UNITED STATES PATENT AND TRADEMARK OFFICE

Office Action Summary

10/642,835

- 1) ☒ Responsive to communication(s) filed on 27 June 2007.
- 2a) ☒ This action is **FINAL**. 2b) ☐ This action is non-final.
- 3) ☐ Since this application is in condition for allowance except for formal matters, prosecution as to the merits is closed in accordance with the practice under *Ex parte Quayle*, 1935 C.D. 11, 453 O.G. 213.

Fig. 1

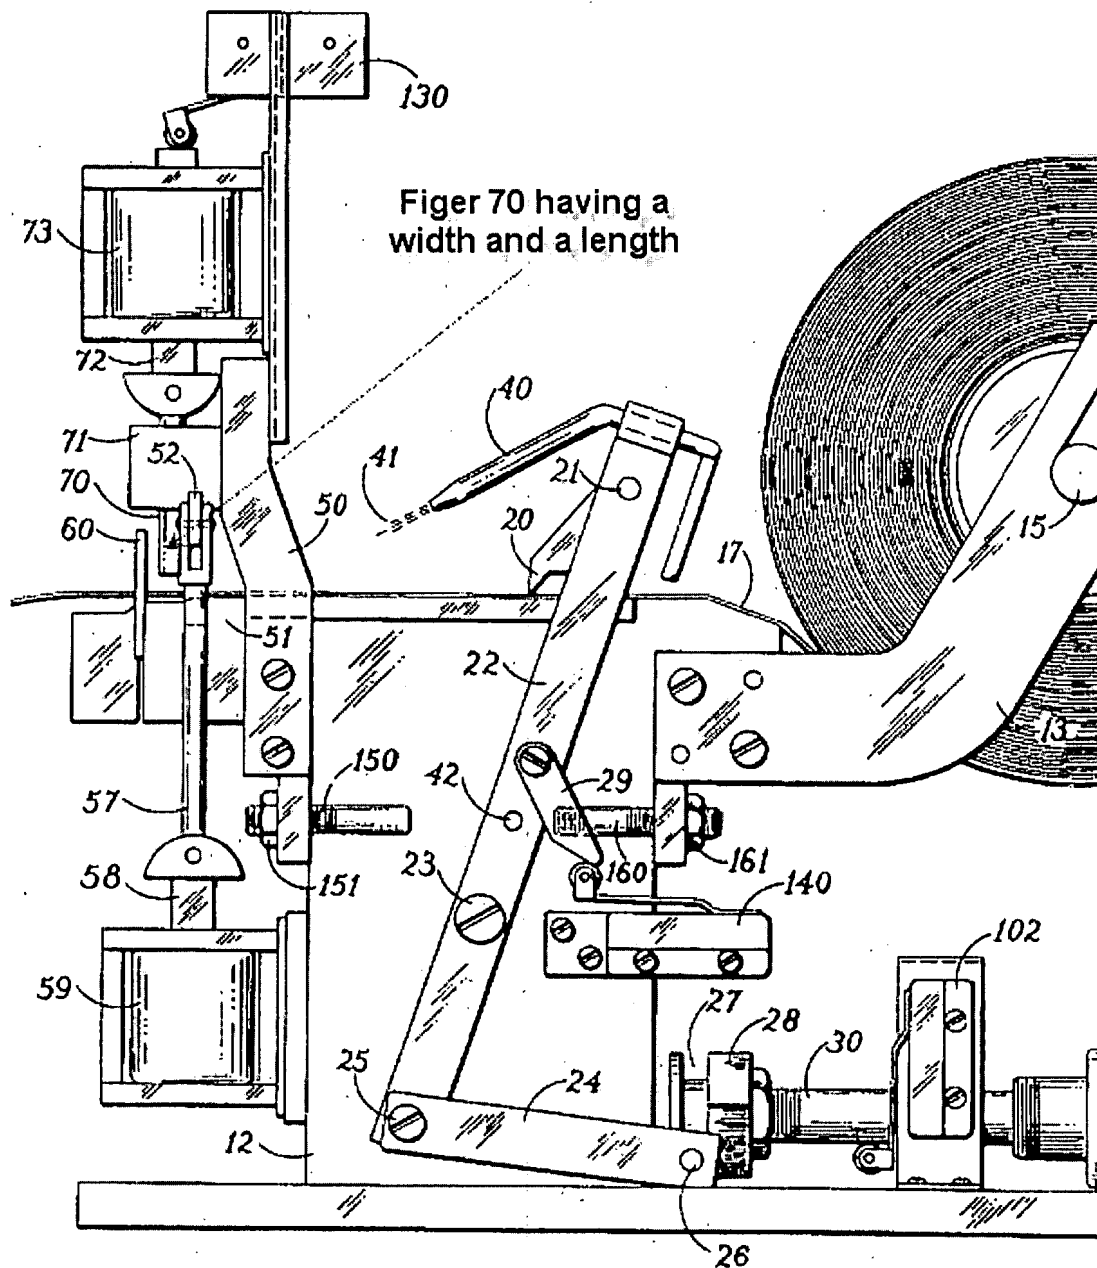
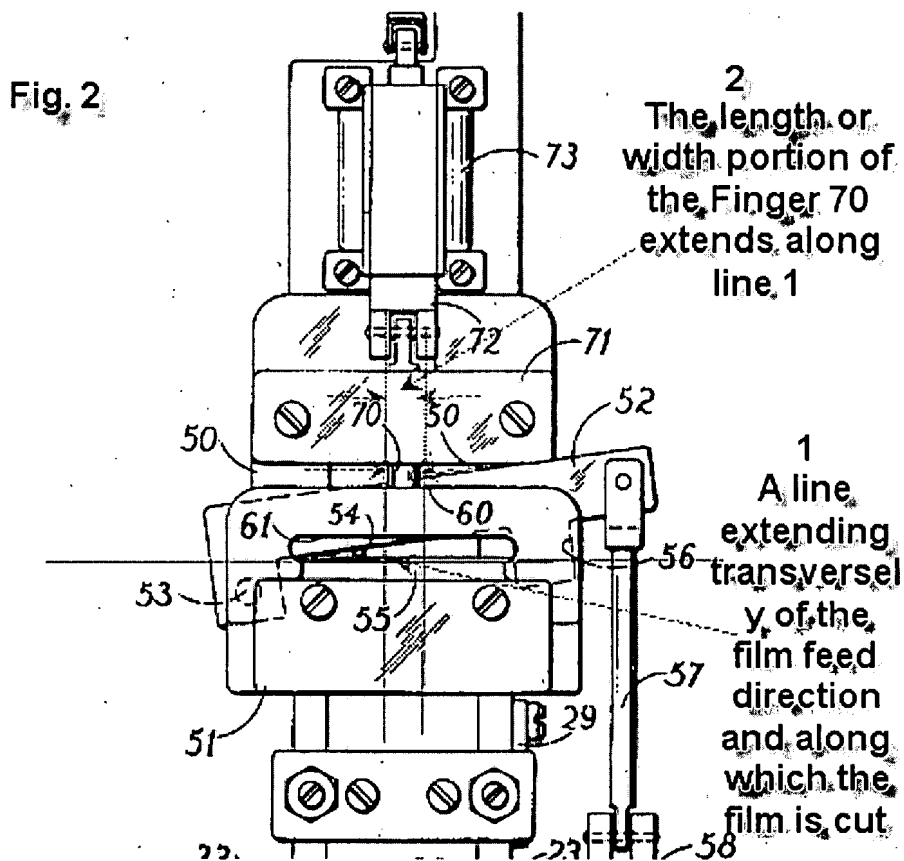
Applicant's argument that neither Price nor Oakes teaches or suggests that the film is clamped "along the length of a transverse line on which it is being cut" is not persuasive. Firstly claim 1 merely recites, "the film is clamped by the film holder, along the length of the line extending transversely of the film feed direction and along which the film is severed by the trimming device." See lines 11-13 in claim 1. It should be noted that the clamp holder or finger 70 clamps the film on a line that has the same length as the width of the clamp holder 70. The line located distanced from the cutting edge of the blade or line 2. See Figs. 1-2 below. The cutting edge 55 of the trimming device cuts the film 17 along the length of a line 2, which extends transversely of the film feed direction. Line 2 is parallel to the line that the film holder clamps the film 17. It should be noted that the line at which the film holder clamps the film is located along the length of the line 2.

In an alternative interpretation of claim 1, line 2 could represent the line on which the film is clamped by the film holder and extending transversely of the film feed direction. It should be noted that the film is clamped along the length of the line 2. The film holder

clamps the blade at line 2 which is located along the line that film is severed by the trimming device. It should be noted that “along which the film is severed by the trimming device” is being read as independent from “along the length of a line extending transversely of the film feed direction” so that the location of severance need not be on the same location as where the film is clamped. Therefore, the film is clamped along the length of the line extending transversely of the film feed direction and along the line that the film is cut.

Applicant's argument that the finger 70 is spaced apart from the knife 52 and does not clamp the film 17 at the cutting line is not persuasive. Firstly, claim 1 and other claims in the instant application do not call for the film to be clamped at the cutting line. Secondly, claim 1 calls for the film to be clamped along the line that the film is cut. As stated above, the film holder 70 camps the film 17 at the line that extends along or parallel to the line that the film is cut by the knife 52. See Figs. 1-2 below.

Applicant's argument that the finger or film holder 70 only supports the film at a single point is not persuasive. As shown in Figs. 1-2, film holder 70 has a width portion extending transversely in the feed direction of the film. The width of the film holder is spaced from trimming device 52 but extends along the line that the trimming device cuts the film. The width of the film holder could be considered as a large single point, but it has a length width that extends along a line transversely of the film feed direction.

Applicant also asserted that the term finger in Price reference would suggest that the finger 70 does not provide clamping along the length of a transverse line on which the film is cut. This is not true. As stated above, the finger 70 clearly shown to has a width portion that extends along a length of a transverse line which is also extended along the line that the film

is cut. It should be noted that the claims do not explicitly recite the length of the line extending transversely of the film feed direction and the length of the line on which the film is severed by the trimming device. Therefore, minimum extension of the finger 70 along a line extending transversely of the claim limitations set forth in claim 1.

Applicant's argument that Oakes also does not teach that the film is clamped by the bar 130 at the cutting line of the blades 122 and 164 is not persuasive. As stated above, claim 1 does not require that the film to be clamped at the cutting line at which the film is cut by the trimming device. Claim 1 merely recites, "the film is clamped by the film holder, along the length of a line extending transversely of the film feed direction and along which the film is severed by the trimming device." Claim 1 requires that the film to be clamped along the

line that film is cut by the trimming device. However, claim 1 does not require that the film to be clamped by the film holder at the same line that the film is cut by the trimming device or along the same line that the film is cut by the trimming device.
